RHODE ISLAND DEPARTMENT OF TRANSPORTATION

RHODE ISLAND CONTRACT NO.2015-CB-028

Bridge Nos. 483-486 Pier Cap Replacement and Miscellaneous Bridge Repairs

ADDENDUM NO. 2 Prospective bidders and all concerned are hereby notified of the following changes in the Plans, Specifications, Proposal and Distribution of Quantities for this contract. These changes shall be incorporated in the Plans, Specifications, Proposal and Distribution of Quantities, and shall become an integral part of the Contract Documents.

BRIDGE DECK AT JOINT REPAIR DETAIL
REPAIR SHALL BE DONE FROM TOP OF THE DECK

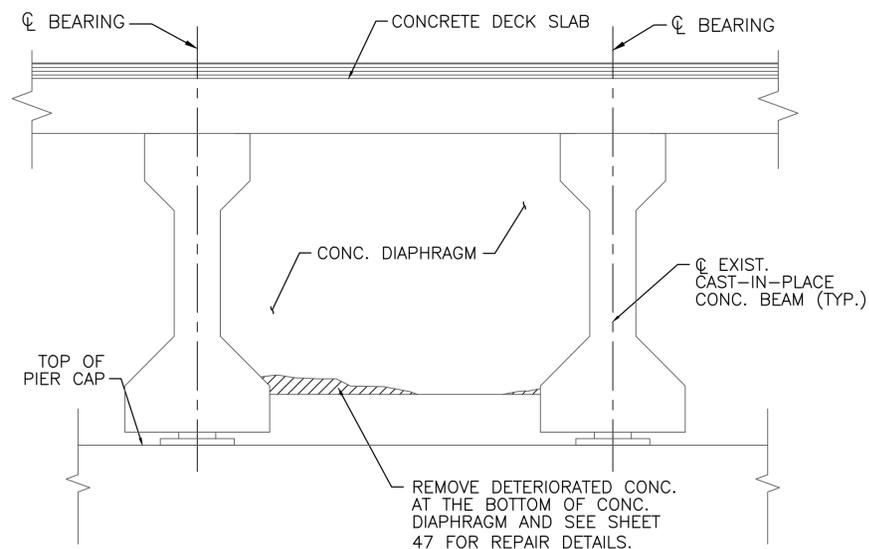
9. Sheet No. 48 Beam Repair Details
Delete Sheet No. 48 in its entirety and replace with revised Sheet No. 48 (R-1) attached to this Addendum No. 2. Limits of bridge deck repair have been added to "Bridge Deck at Joint Repair Detail."

EXPANSION JOINT DETAIL AT CURBS 5
SCALE: 1" = 1'-0"

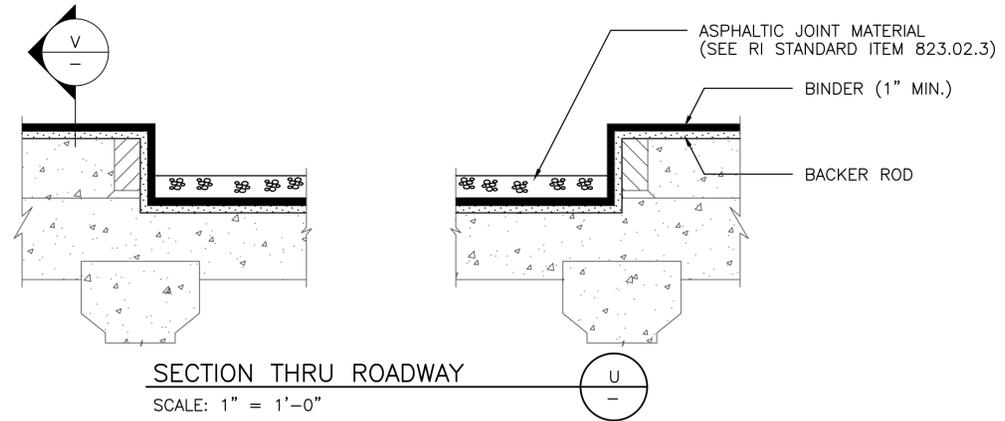
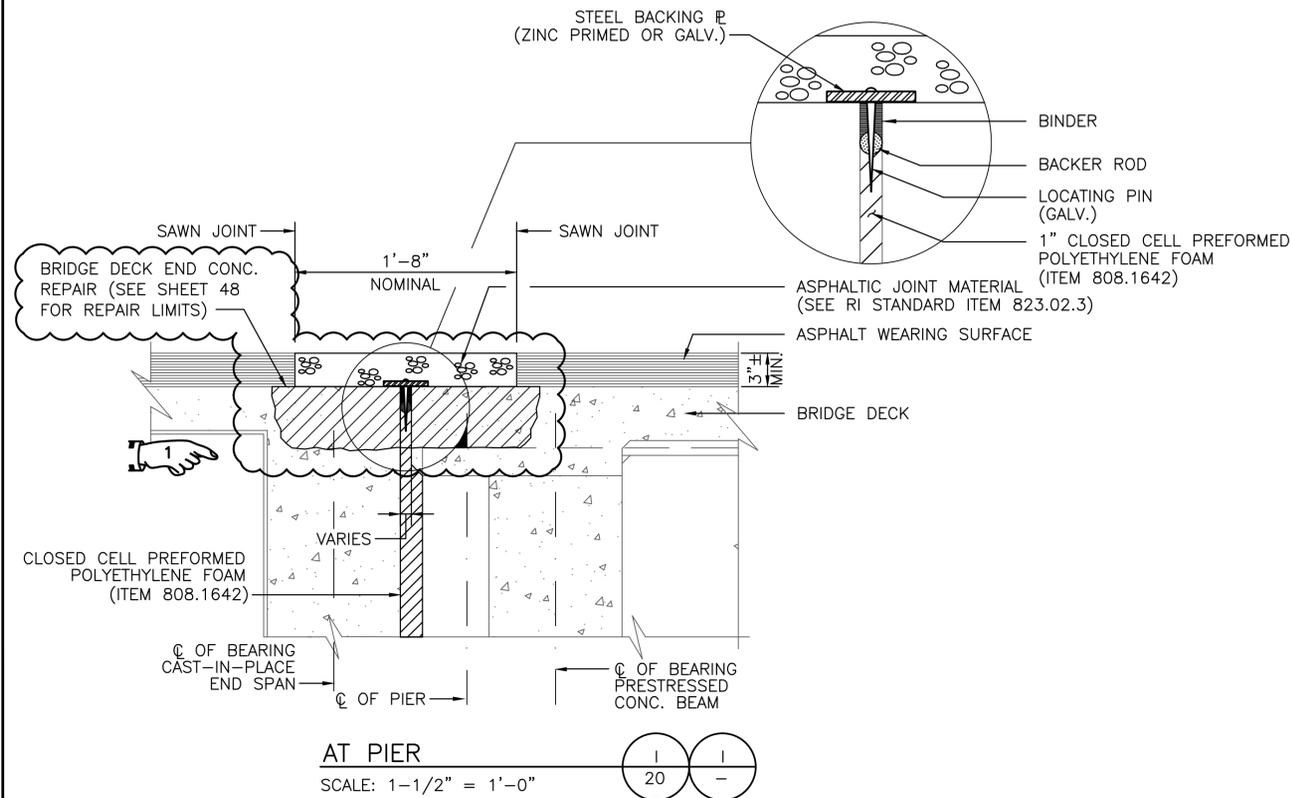
10. Sheet No. 50 Asphaltic Expansion Joint System
Delete Sheet No. 50 in its entirety and replace with revised Sheet No. 50 (R-1) attached to this Addendum No. 2. Limits of bridge deck repair have been added to Detail 5 and Section I.

FIXED JOINT AT ABUTMENT
SCALE: 3/4" = 1'-0"

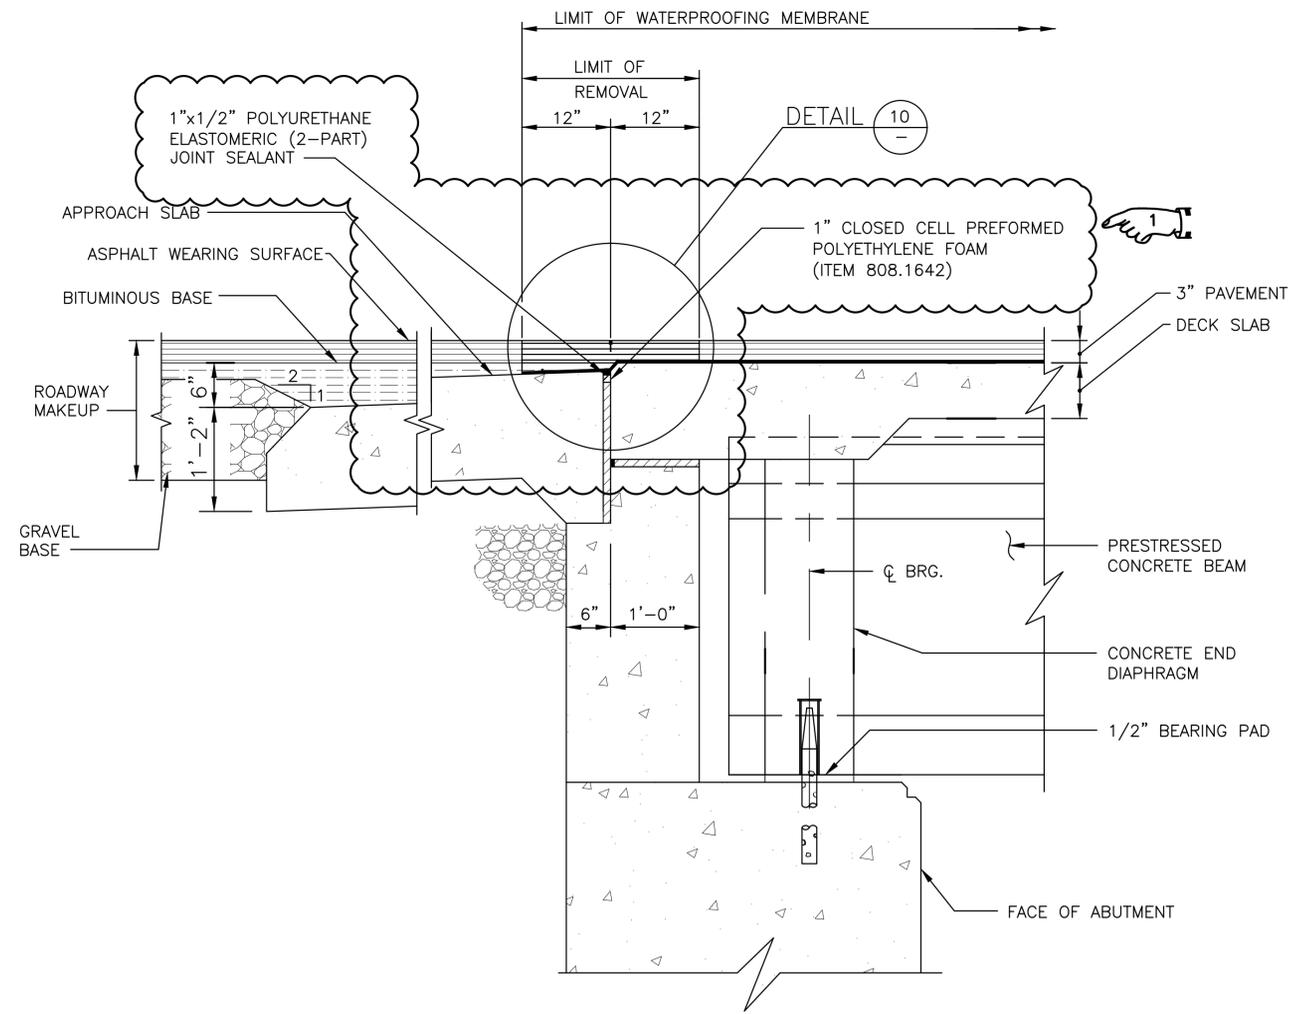
11. Sheet No. 51 Fixed Joint Details
Delete Sheet No. 51 in its entirety and replace with revised Sheet No. 51 (R-1) attached to this Addendum No. 2. Proposed limits of joint sealant and closed cell foam have been revised in "Fixed Joint at Abutment" and Detail 10.
